Addendum No. 4

Date: February 28, 2012

PROJECT: Long Branch – George L. Catrambone Elementary School

CONTRACT No.: ET-0068-C01

2 TYP MASONRY WALL TYPE DETAILS
A4.16 SCALE: 1-1/2" = 1'-0"

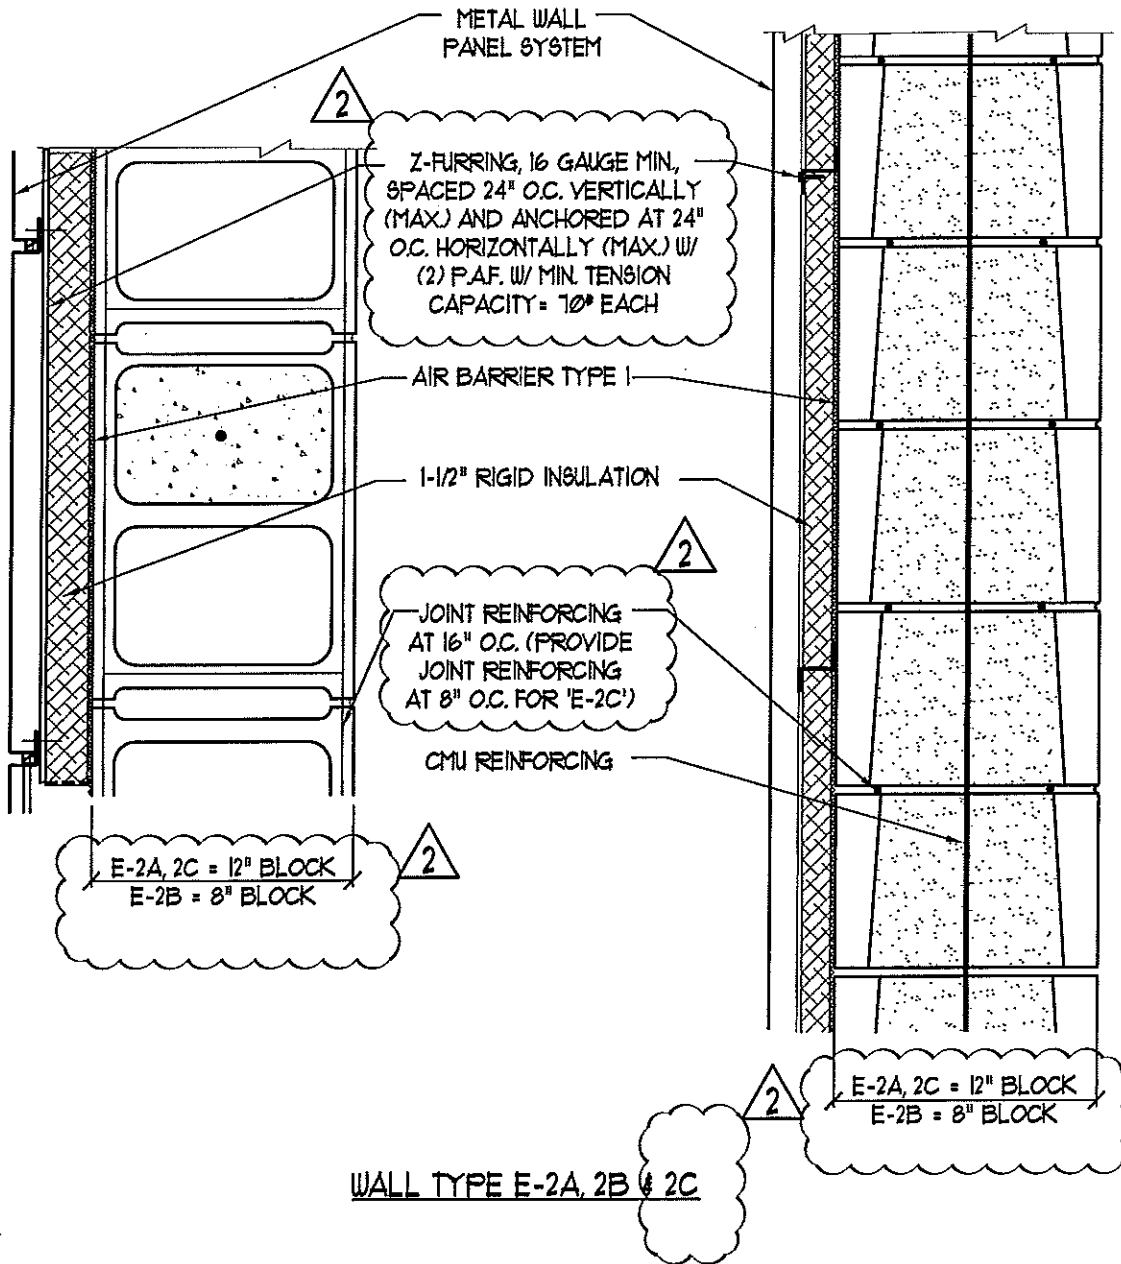
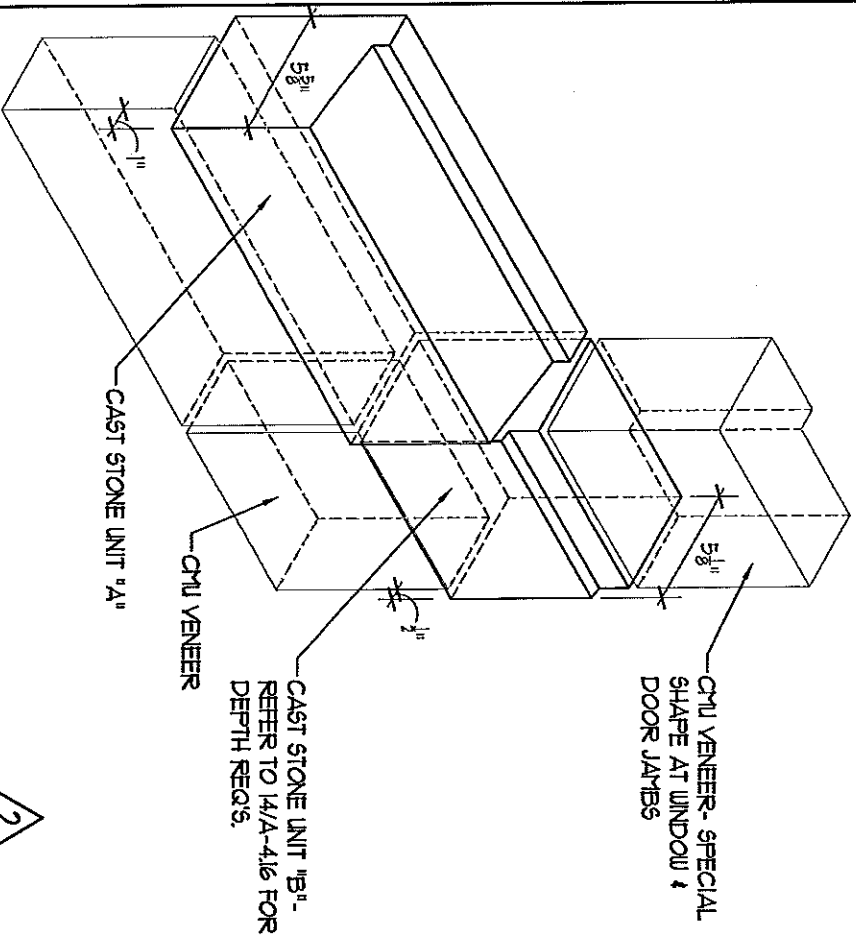
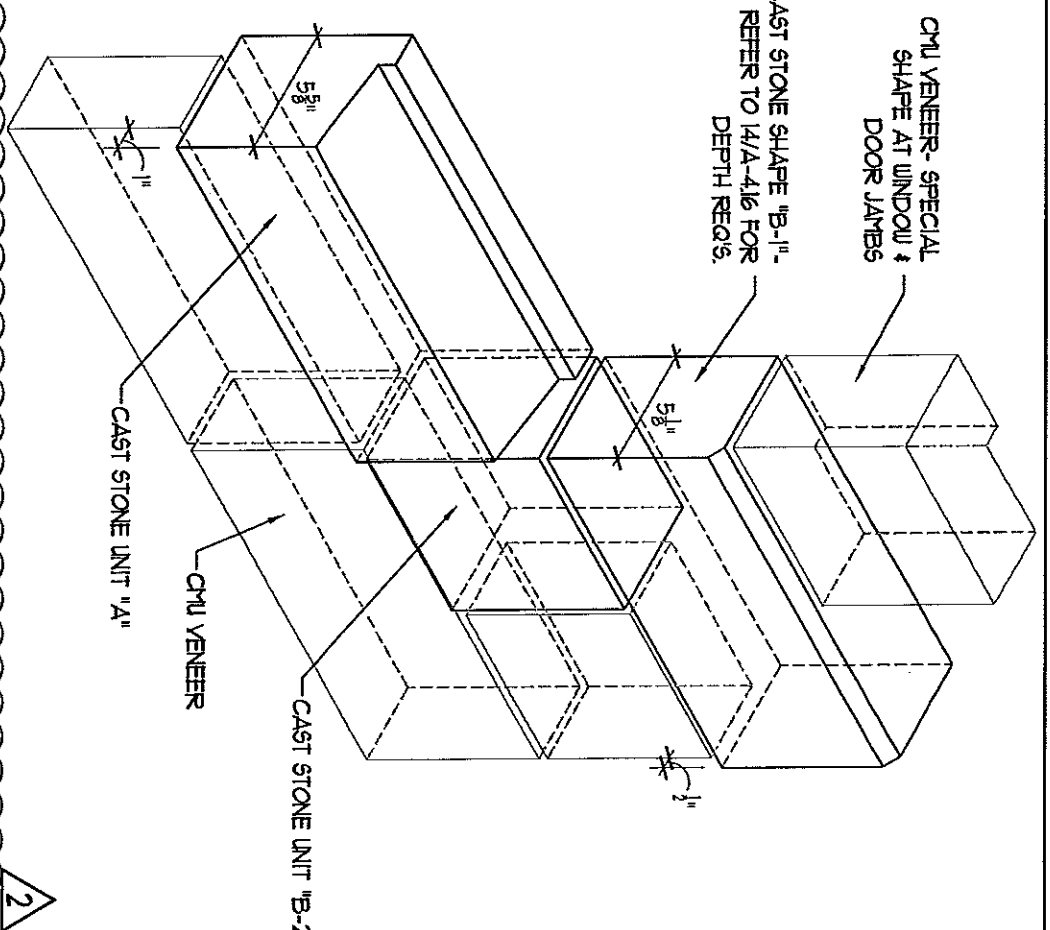
- Detail 2/A-4.16:
 - Revise detail per SK-20.
- Detail 14/A-4.16:

- Revise Cast Stone Units “A” and “B” per SK-21.
- Provide new Cast Stone Units “B-1” and “B-2” per SK-21.
- Change Cast Stone Unit “C-1” face height dimension from 6” to 5-5/8”.
- Change Cast Stone Unit “D” face height dimension from 3-5/8” to 4” and change overall height from 4-5/8” to 5”.
- Detail 5/A-4.16:
 - Refer to SK-22 for new “Cast Stone Isometric Detail”
- Detail 6/A-4.16:
 - Refer to SK-22 for new “Cast Stone Isometric Detail”

REFERENCED DRAWING
 DETAIL/SHEET # 2 / A-1.4
 DATE: 10-20-11

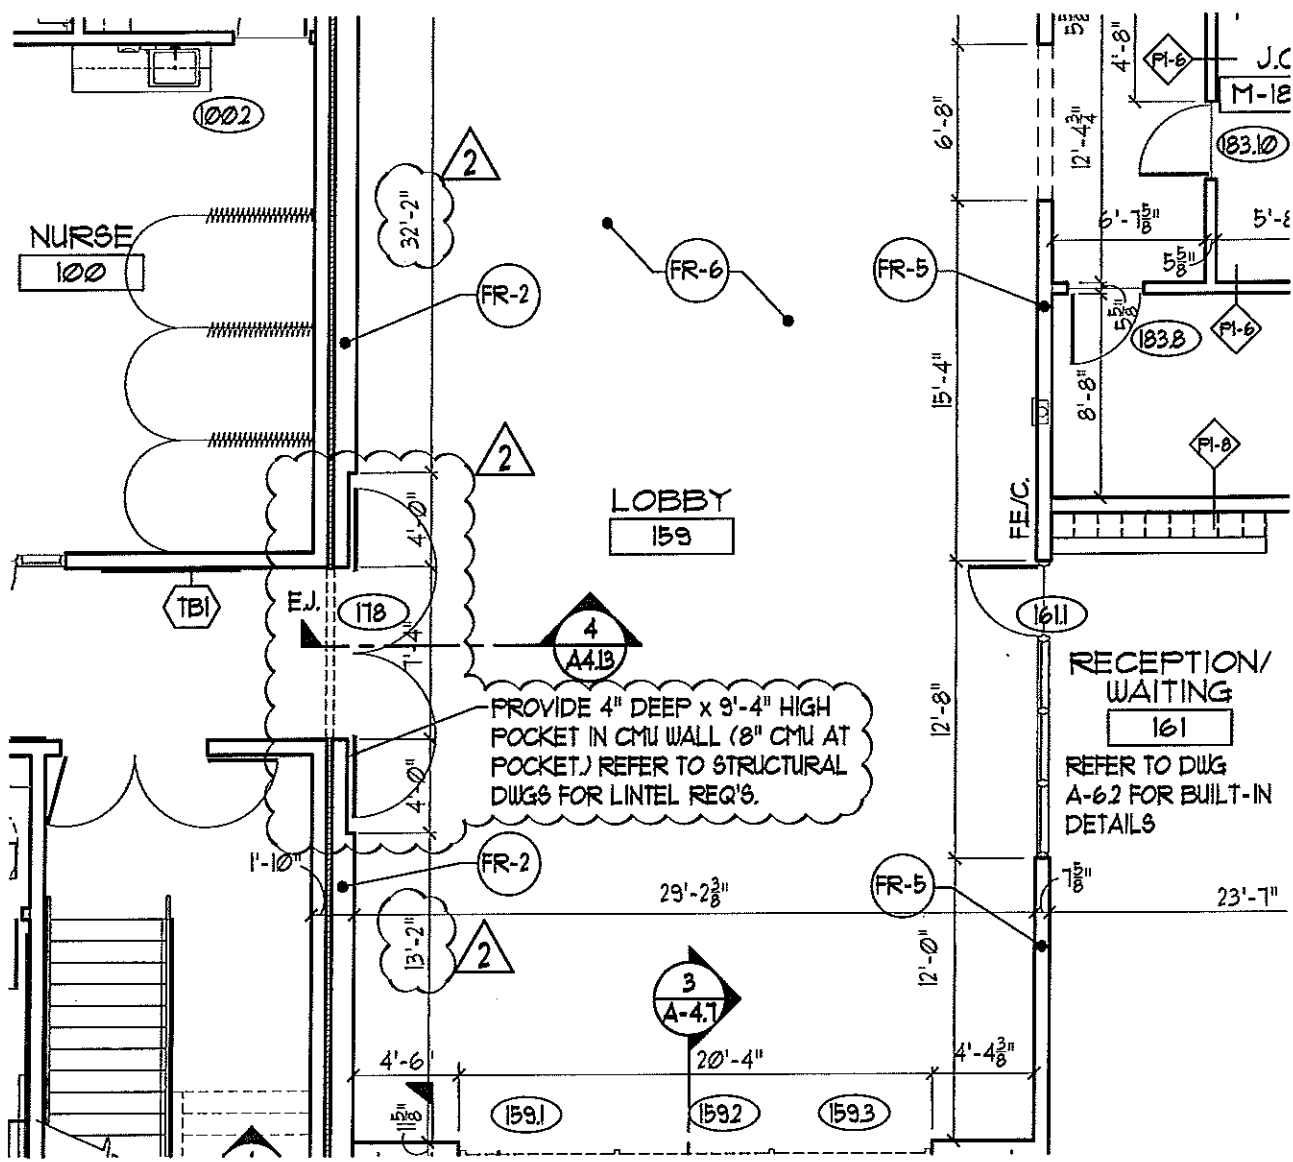
- Detail 2/A-1.4:
 - Revise detail to provide pocket in CMU wall at door #178 per SK-23.
- Detail 3/A-1.4:
 - Details shall be modified per attached SK-14.

21 LATERAL BRACING @ RM. 222 & 218 DIVIDER PARTITION
 A-6.2 SCALE: 3/4" = 1'-0"

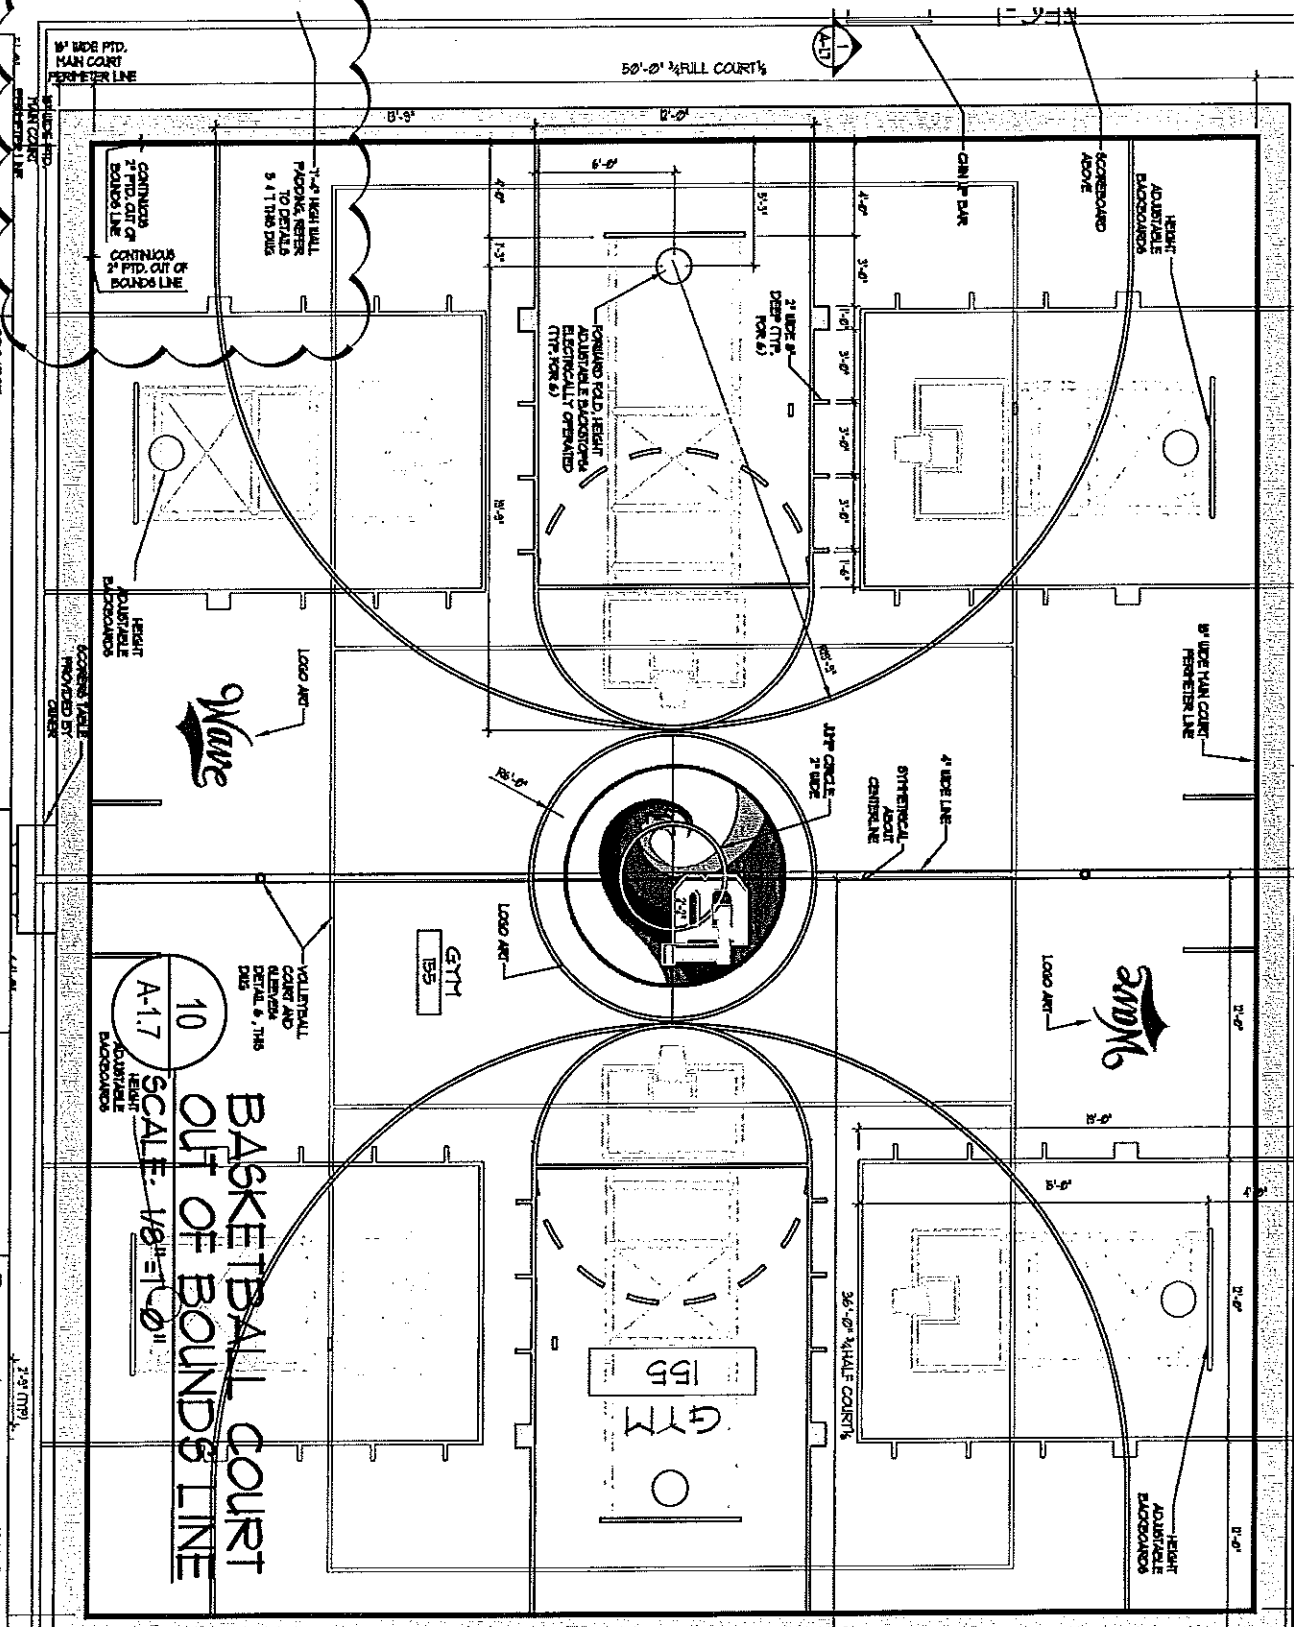
- Revise detail title to be detail "6/A-6.2"
- Detail 7/A-6.1:
 - Revise detail title to be detail "7/A-6.2"
 - On 'PLAN VIEW', revise note to read 'DELETE SHELVING AT PRE-K/K CLASSROOMS, TO ACCOMMODATE TEACHER'S WARDROBE, REFER TO DTL. 5/A-6.1'
- Detail 8/A-6.2:
 - Revise detail to add partition bracing and relocate partition support structure per SK-24.
- Detail 9/A-6.2:
 - Add to following notes: 'PROVIDE BRACING AS DESIGNED BY THE CONTRACTOR'S SPECIALTY ENGINEER (DELEGATED DESIGN)' and 'PROVIDE COLD FORMED METAL STUD SOFFIT FRAMING SYSTEM'
- Detail 10/A-6.1:
 - Revise detail title to be detail "10/A-6.2"
- Detail 14/A-6.2:
 - Delete detail in its entirety.
- Detail 18/A-6.2:
 - Revise detail title scale to indicate ' SCALE: 1/4"= 1'-0" '
- Add new detail 21/A-6.2 per SK-25.

10
 A-1.7
 SCALE: 1/8" = 1'-0"

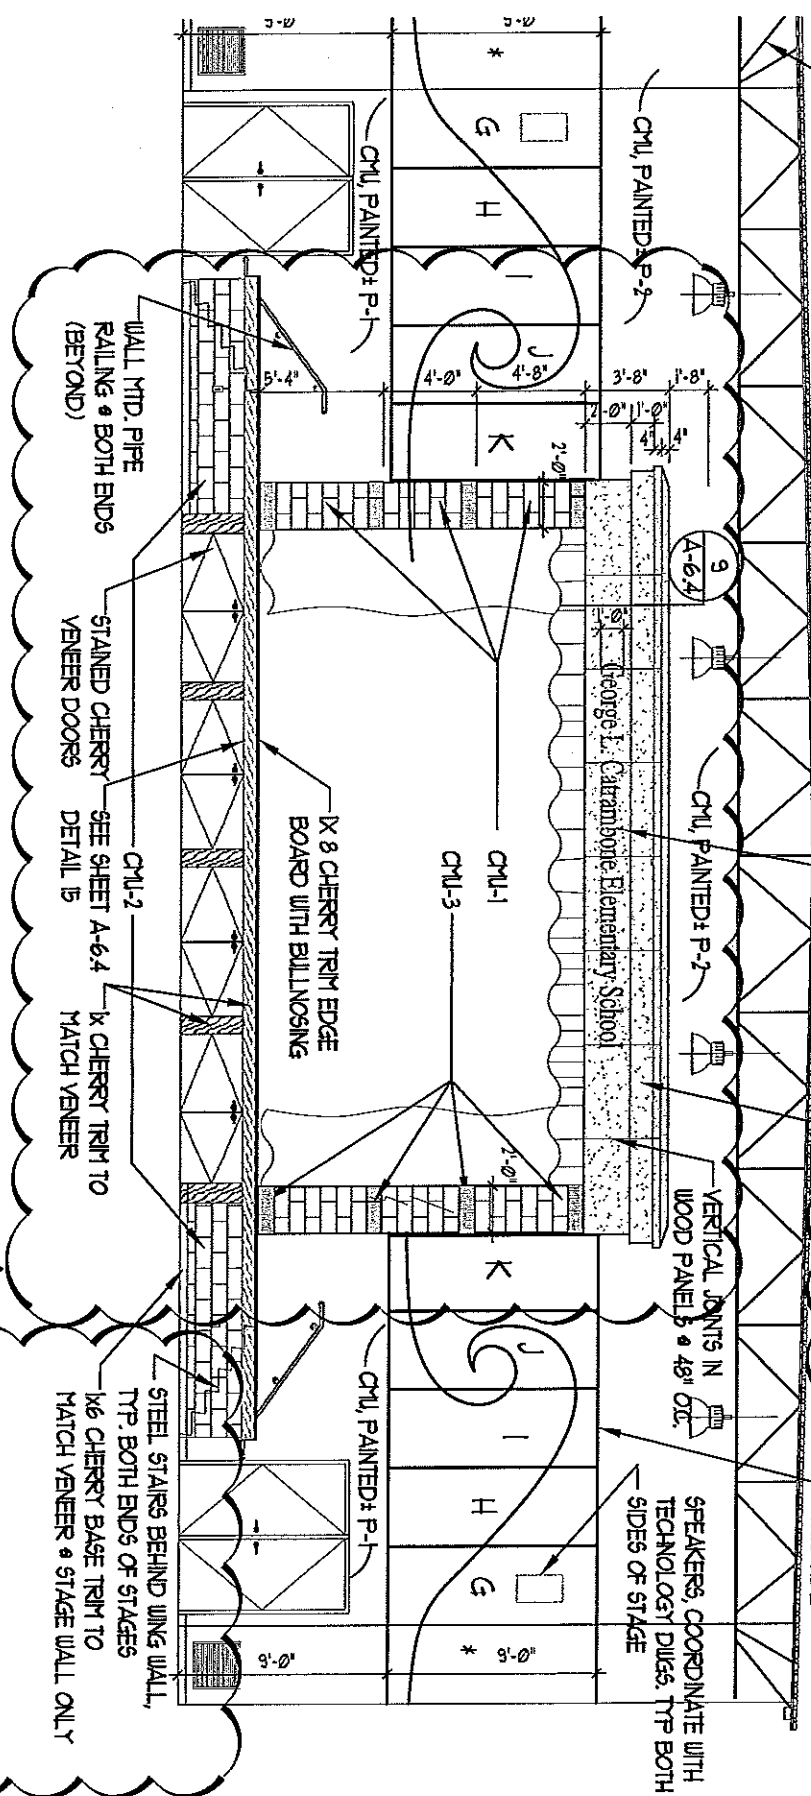
- Detail 10/A-1.7:
 - Modify the 18" Wide Main Court Perimeter Line to add 2" wide painted "Out of Bounds Line" per SK-26.

5 CURTAIN WALL TYPES

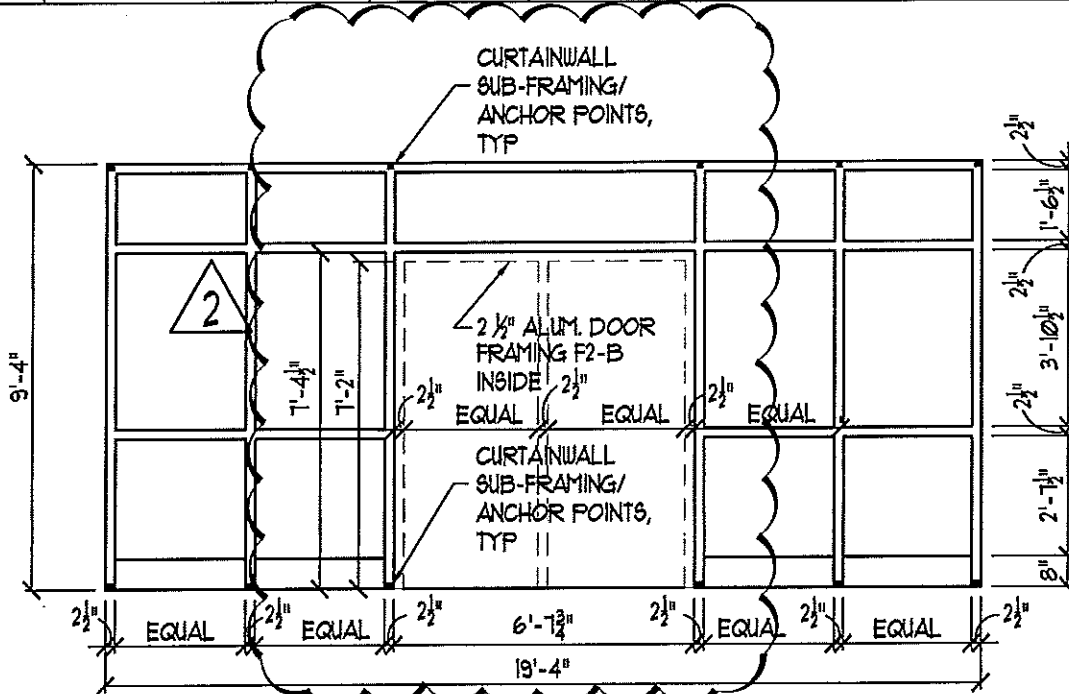
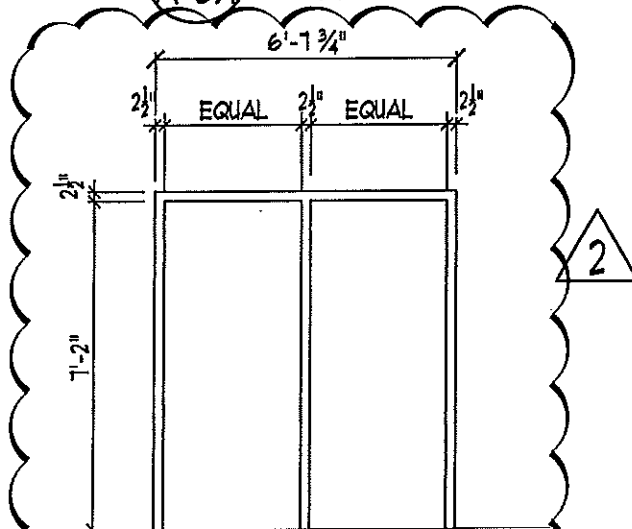
- Detail 1/A-5.4:
 - Delete detail title and replace with "DOOR FRAMES".
 - Add door frame type 'F2-B' as an insert to curtain wall 'CW-9' per SK-30.
 - Revise note "CONCEALED REMOVABLE MULLION" to "CONCEALED REMOVABLE MULLION AS INDICATED IN HARDWARE SCHEDULE"
 - Add door frame type 'F2-B' as an insert to curtain wall 'CW-9' per SK-30.
- Detail 2/A-5.4:
 - Delete detail title and replace with "DOOR FRAMES".
 - Revise note "CONCEALED REMOVABLE MULLION" to "CONCEALED REMOVABLE MULLION AS INDICATED IN HARDWARE SCHEDULE"
- Detail 3/A-5.4:
 - Add door type '02A' wood door per SK-30.
- Detail 4/A-5.4:
 - Delete Window Types 'W-7' and 'W-11'
- Detail 4/A-5.4:
 - Delete Curtain Wall Type 'CW-6'
- Detail 5/A-5.4:
 - Revise curtain wall Type 'CW-9' per SK-30.
